Subject: **Palo Verde Nuclear Generating Station (PVNGS)
Units 1, 2, and 3
Docket Nos. STN 50-528, 50-529, and 50-530
APS Third 6-Month Status Report on the PVNGS Overall
Integrated Plan for Mitigation Strategies for Beyond-Design-
Basis External Events (Order Number EA-12-049)**

**APS Third 6-Month Status Report on the PVNGS Overall
Integrated Plan for Mitigation Strategies for
Beyond-Design-Basis External Events**

Figure 1

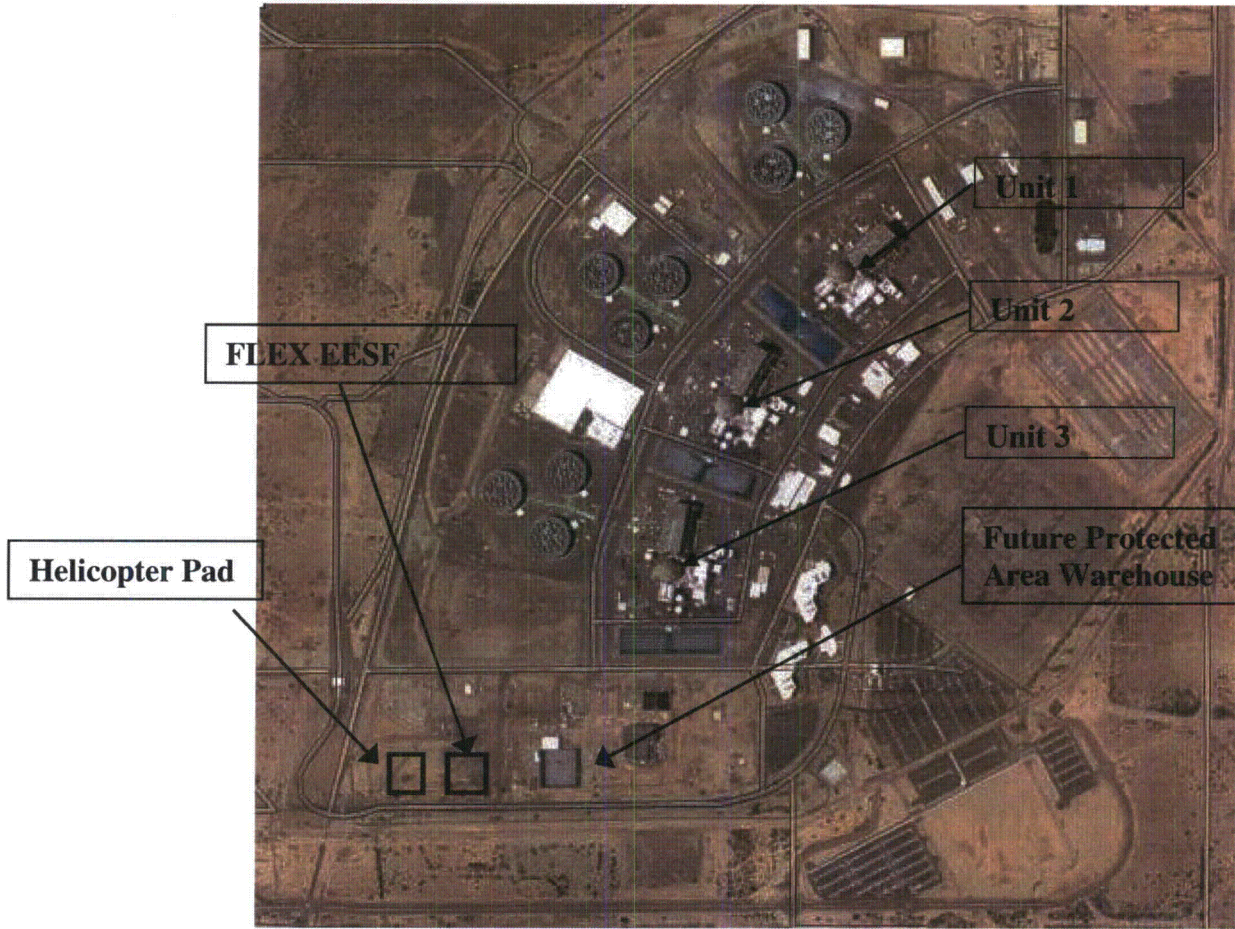
Overall Integrated Plan Open Items	Status
<p>OI1- A storage location for FLEX equipment needs to be selected.</p>	<p>Complete</p> <p>Location has been selected for FLEX equipment storage. The FLEX Emergency Equipment Storage Facility (EESF) will be located true west of the new Protected Area (PA) warehouse (outside of the PA but inside the Security Owner Controlled Area) and true east of the helicopter pad (See Section 9 Figure 1). Additional details on the locations of the temporary pad, FLEX EESF, and Helipad are included in Figure 2(See Section 9 Figure 2).</p>
<p>OI2- PVNGS FSG is currently a draft document and will need to be finalized. Existing site EOPs will need to be updated to direct use of the PVNGS Extended Loss of All Site AC Guideline during an ELAP. Additionally, a program and procedural control process is under development and will be implemented to meet the requirement of NEI 12-06 (Reference 3).</p>	<p>Started</p> <p>All activities are moving toward completion as scheduled and noted, as applicable, on the Milestone Schedule Status Table in Section 3 of this enclosure.</p>
